# Ohio Environmental Protection Agency (Ohio EPA) And Ravenna Army Ammunition Plant (RVAAP) 2021 Correspondences

**Subject: Ramsdell Quarry Landfill, Portage County**
**End of Post-Closure Care Period**

**Subject: Comments for Draft Record of Decision for Soil, Sediment and Surface Water at RVAAP-06 C-Block Quarry at the Former Ravenna Army Ammunition Plant, Portage and Trumbull Counties, Ohio, Contract No. W912QR-21-D-0016, October 27, 2021**

**Subject: Concurrence with Response to Ohio EPA Comments on the "Draft Non Time Critical Removal Action Work Plan for RVAAP-34 Sand Creek Disposal Road Landfill" Based on Conference call of March 24, 2021**

**Figure 4-1**
**Proposed Sediment Sampling Locations at Ore Storage Pond**
**CC RVAAP-79 DLA Ore Storage Sites**

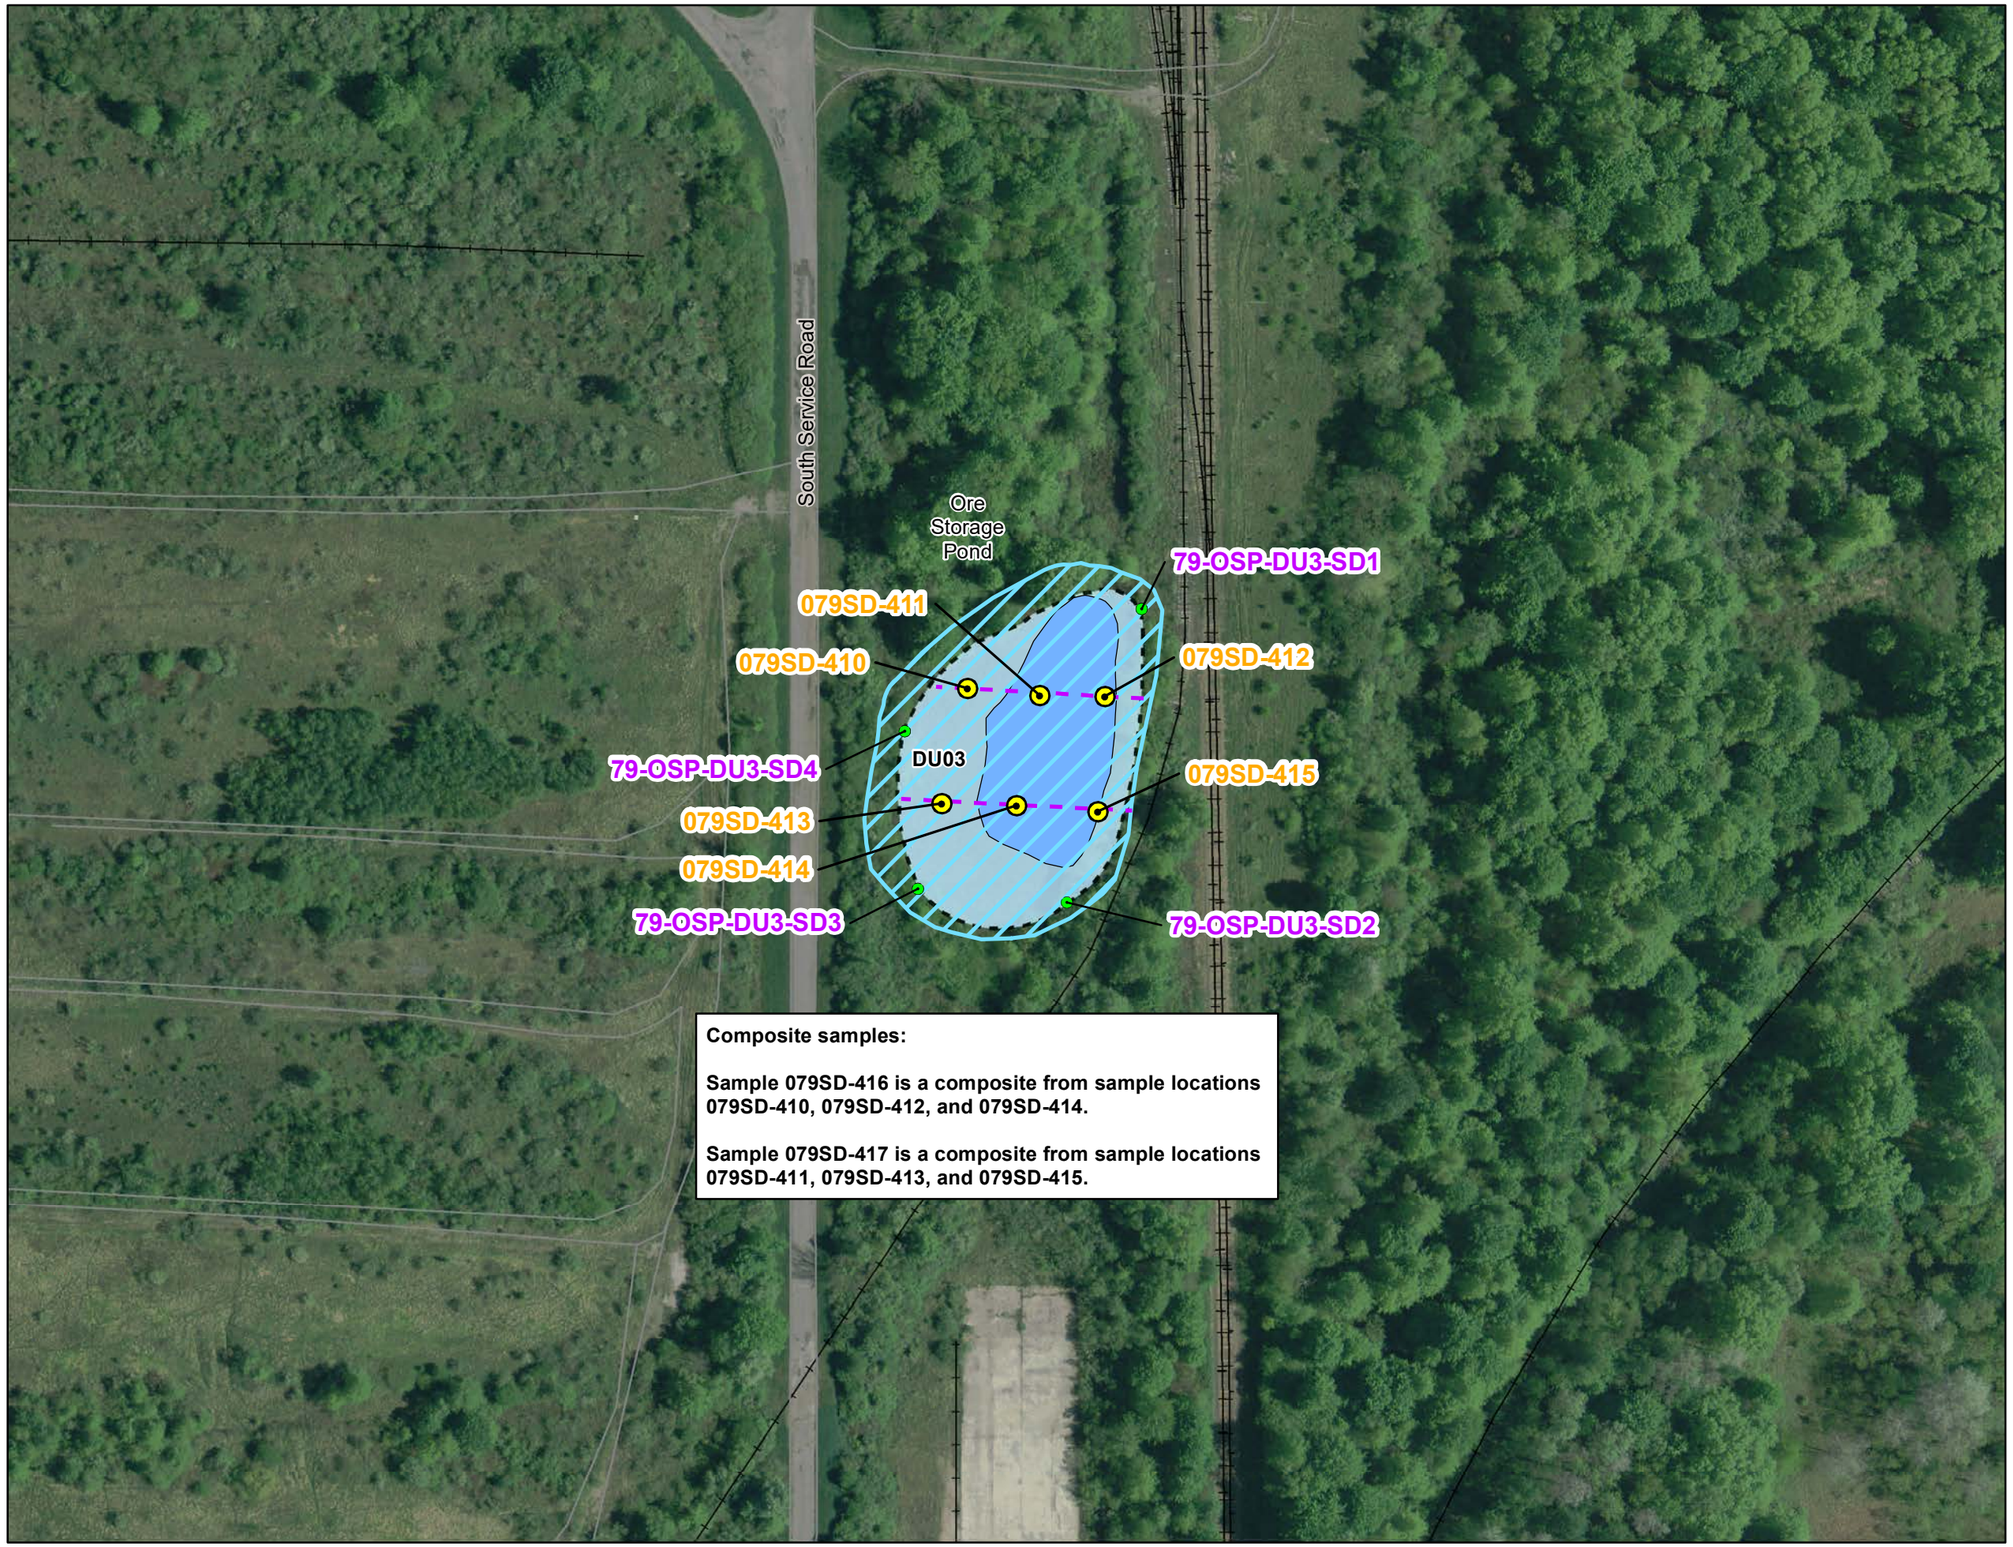
**2.) Section 4.1: Sediment Sampling**: The current WPA is suggesting a single transect that runs through the area of the pond with largest area of open water. Ohio EPA recommends two transects running perpendicular to and instead of the current line, one crossing approximately between samples 411 and 412, and one approximately between 413 and 414 (Figure 4-1 draft WPA). A total of six samples as proposed in the draft WPA is sufficient, with three from each suggested transect. Wetland sediment/soil should also be included but only within the historical boundary of the ore storage pond. The proposed single transect in the draft WPA avoids the sediment sample with the maximum concentration of arsenic. The two-transect approach should provide representative sediment samples for the bioassay work.

***Response*: Agree.** *Please see attached revised Figure 4-1 for new sample transects and locations.*

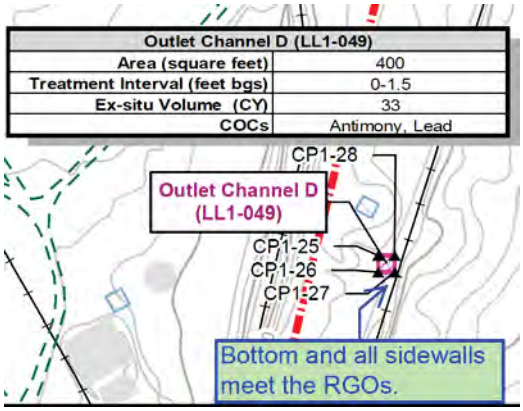
4. Load Line 1, excavation Building CB-2 is shown below. Bedrock is present throughout the excavation at approximately 0.5' to 1' below ground surface - no bottom sample. Railroad ballast is present in two-thirds of the excavation, including the west sidewall and portions of the north and south sidewalls – no samples of railroad ballast. Sample collected from east sidewall that is soil, and wrapped around to the adjoining portions of the north and south sidewalls that are also soil to make one sidewall DU. The sample meets the applicable RGOs and the excavation can be backfilled pending the post-excavation survey.

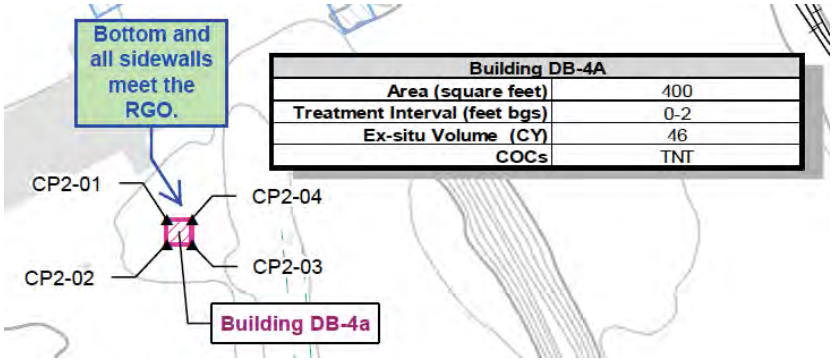
5. Load Line 1, Outlet Channel D is shown below. The applicable RGOs have been met and the excavation can be backfilled pending the post-excavation survey.

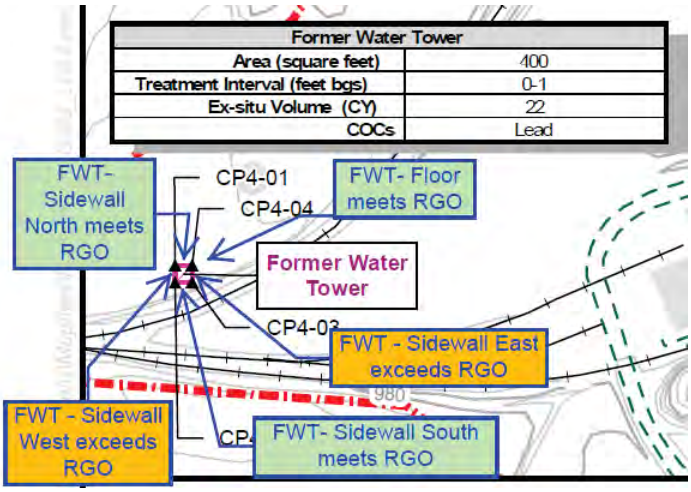
7. Load Line 4, excavation Building G-8(b) is shown below. Sidewall North exceeds the RGO for Benzo(a)pyrene; therefore, additional soil will be removed in this direction followed by an additional sample.

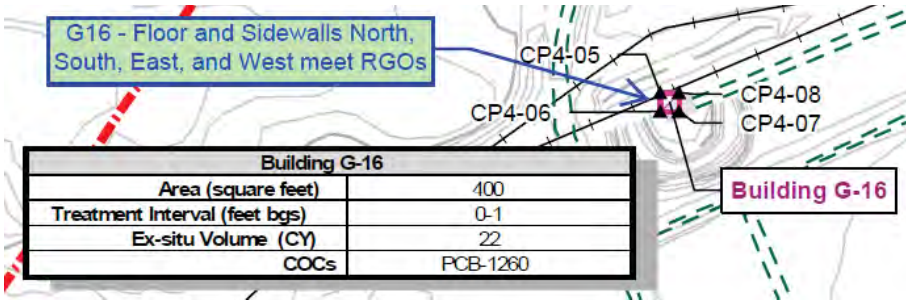
8. Load Line 4, Former Water Tower excavation is shown below. The east and west sidewalls exceed the RGO; therefore, additional soil will be removed to the east followed by an additional sample, and additional soil will be removed to the west followed by an additional sample.

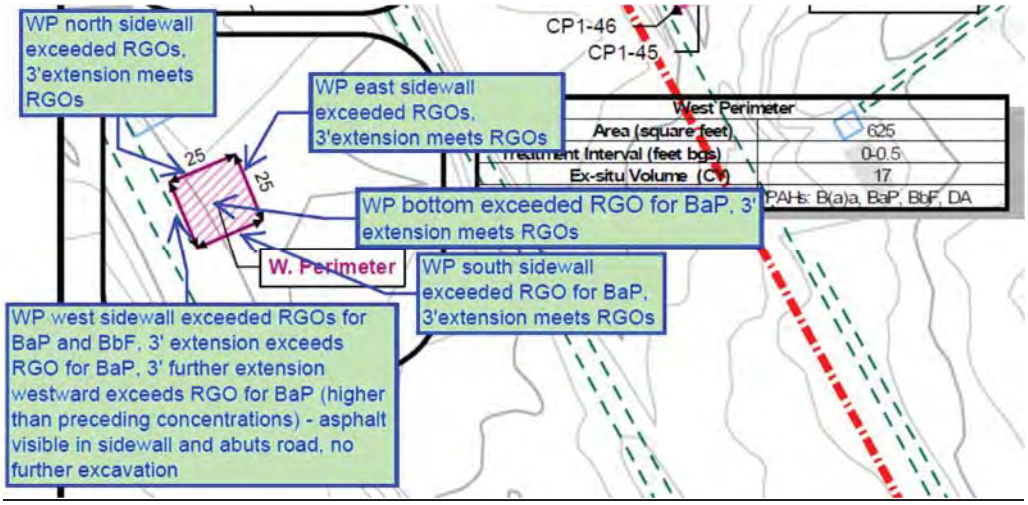
d. The sample for the further extended west sidewall continues to exceed the RGO for BaP (4.48 mg/kg). This concentration is higher than the preceding result (see above).

e. The west side of this excavation abuts a road. An asphalt layer is visible in the extended sidewall. As discussed with the Army, the continuing BaP exceedance is likely due to the asphalt road and no further excavation is this direction is warranted.

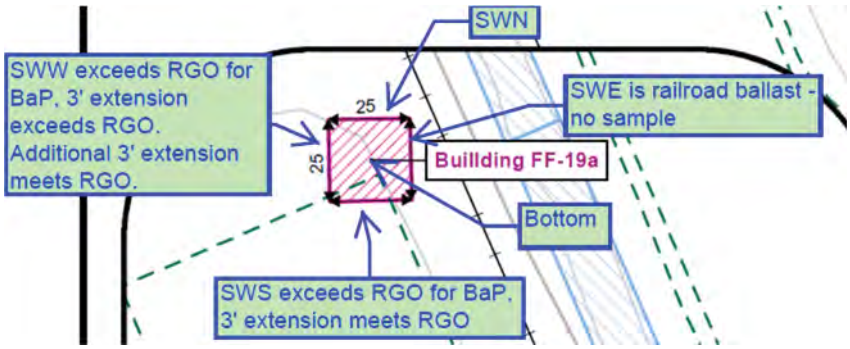
6. Load Line 12, excavation FF-19(a) is shown below. The south and west sidewalls initially exceeded the RGO for BaP (see Excavation Confirmation Report No. 5 dated 1/6/2021). The excavation was extended 3 feet in each of these directions and the additional ISM sample for the extended Sidewall South met the RGO. but the extended sidewall west continued to exceed (see Excavation Confirmation Report No. 7 dated 1/25/2021).
   a. The west sidewall was extended another 3 feet in this direction and the additional ISM sample for BaP meets the RGO.
   b. Therefore, remedial action at the FF-19(a) excavation is complete.

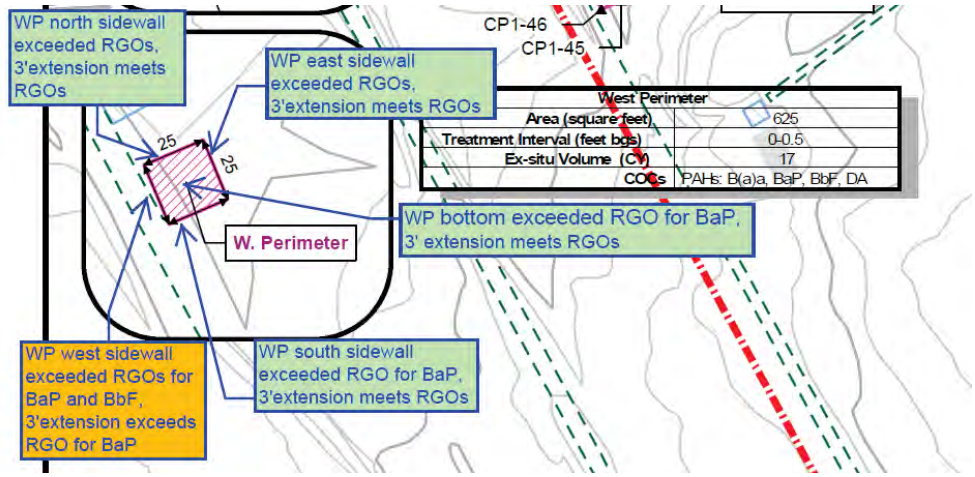
6. Load Line 3, excavation West Perimeter is shown below. All DUs initially exceeded at least one applicable RGO.

a. The west sidewall initially exceeded the RGOs for BaP and BbF. The excavation was extended 3 feet in this direction and an additional ISM sample for BaP and BbF was collected in triplicate for the extended Sidewall West. One of the replicates exceeded the RGO for BaP. The RSDs were less than 35%; therefore, in accordance with the work plan, the maximum replicate concentration of 2.93 mg/kg was compared to the RGO of 2.9 mg/kg. Therefore, additional soil was excavated (another 3 feet westward) and an additional ISM sample for BaP was collected for the further extended Sidewall West (results pending).

b. The bottom initially exceeded the RGO for BaP. The bottom was excavated an additional 3 feet to a total depth of 3.5 feet and the additional ISM sample for BaP for the extended Bottom meets the RGOs.

e. The east sidewall initially exceeded the RGOs for B(a)A, BaP, BbF, and DA. The excavation was extended 3 feet in this direction and the additional ISM sample from the extended Sidewall East for B(a)A, BaP, BbF, and DA meets the RGOs.

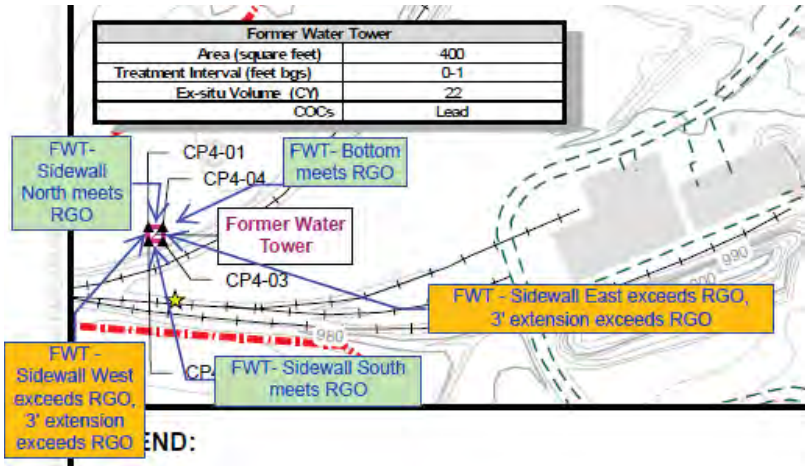
7. Load Line 4, Former Water Tower excavation is shown below. The east and west sidewalls initially exceeded the RGO for lead. The excavation was extended 3 feet in each direction and additional ISM samples collected, both of which still exceed the RGO for lead. Per discussions with the Army, the eastern sidewall will be excavated further to the east until it daylights due to the sloping topography. Per discussions with the Army, the western sidewall will be excavated further to the west approximately 10 feet, beyond which large trees are present, and an additional ISM sample for lead will be collected for the further extended Sidewall West.

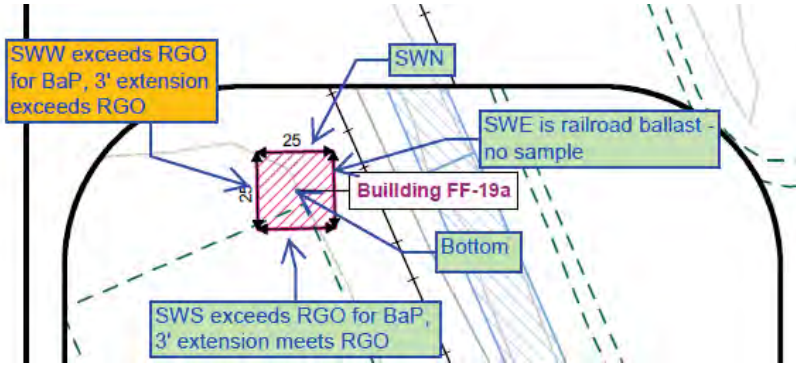
8. Load Line 12, excavation FF-19(a) is shown below.

a. The south sidewall initially exceeded the RGO for BaP. The excavation was extended 3 feet in this direction and the additional ISM sample for BaP for the extended Sidewall South meets the RGOs.

b. The west sidewall initially exceeded the RGOs for BaP. The excavation was extended 3 feet in this direction and the additional ISM sample for BaP exceeds the RGO. Therefore, the excavation was extended another 3 feet in this direction and an additional ISM sample for BaP was collected from the further extended Sidewall West (results are pending).

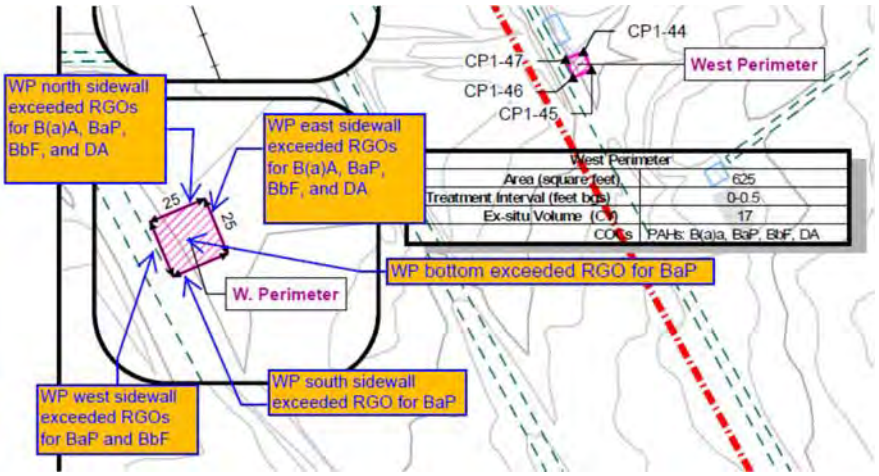
d. The south sidewall exceeded the RGO for BaP. Additional soil will be excavated in this direction and an additional ISM sample for BaP will be collected for the extended Sidewall South.

e. The east sidewall exceeded the RGOs for B(a)A, BaP, BbF, and DA. Additional soil will be excavated in this direction and an additional ISM sample for B(a)A, BaP, BbF, and DA will be collected for the extended Sidewall East.

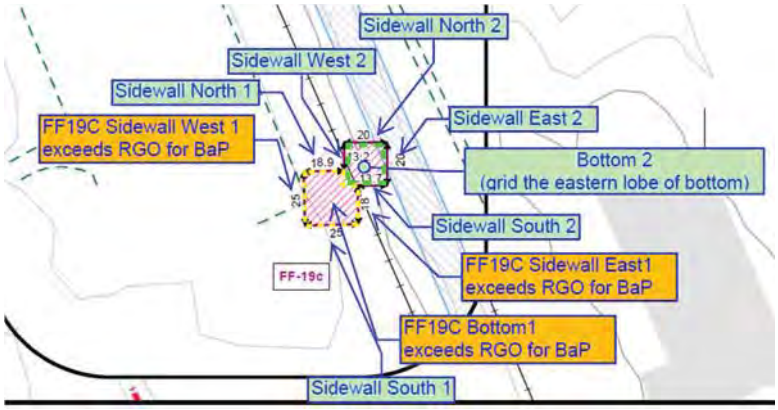
4. Load Line 12, excavation FF-19(a) is shown below. The RGO for BaP was exceeded in the western and southern sidewalls. Additional soil will be excavated at SWS and SWW for treatment, and an additional ISM sample for BaP will be collected for the new southern sidewall and an additional ISM sample for BaP will be collected for the new western sidewall.

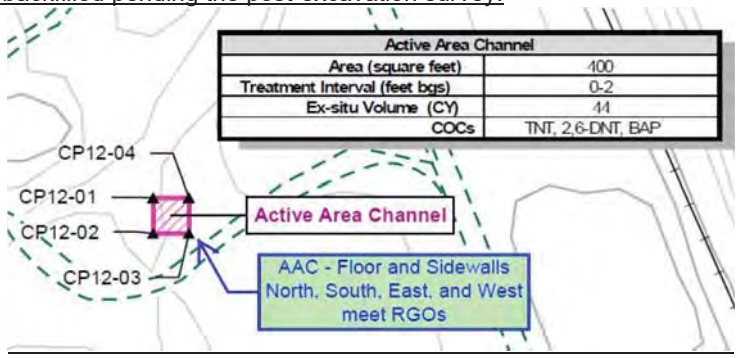
5. Load Line 12, excavation FF-19(c) is shown below. The RGO for BaP was exceeded in Sidewall West 1, Sidewall East 1 and Bottom 1. Additional soil will be excavated at SWW1, SWE1 and Bottom1 for treatment, an additional ISM sample for BaP will be collected for the extended SWW1, an additional ISM sample for BaP will be collected for the extended SWE1, and an additional ISM sample for BaP will be collected for the extended Bottom1.

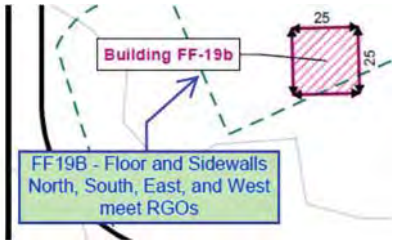
6. Load Line 12, Active Area Channel is shown below. The applicable RGOs have been met and the excavation can be backfilled pending the post-excavation survey.

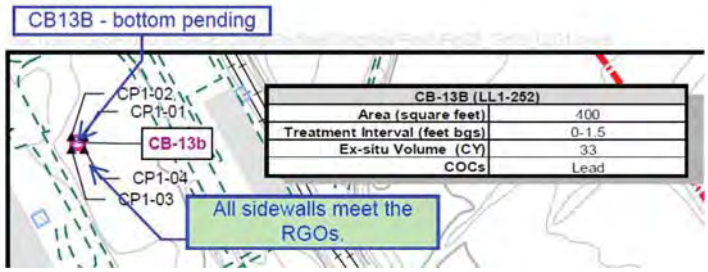
7. Load Line 12, excavation FF-19(b) is shown below. The applicable RGOs have been met and the excavation can be backfilled pending the post-excavation survey.
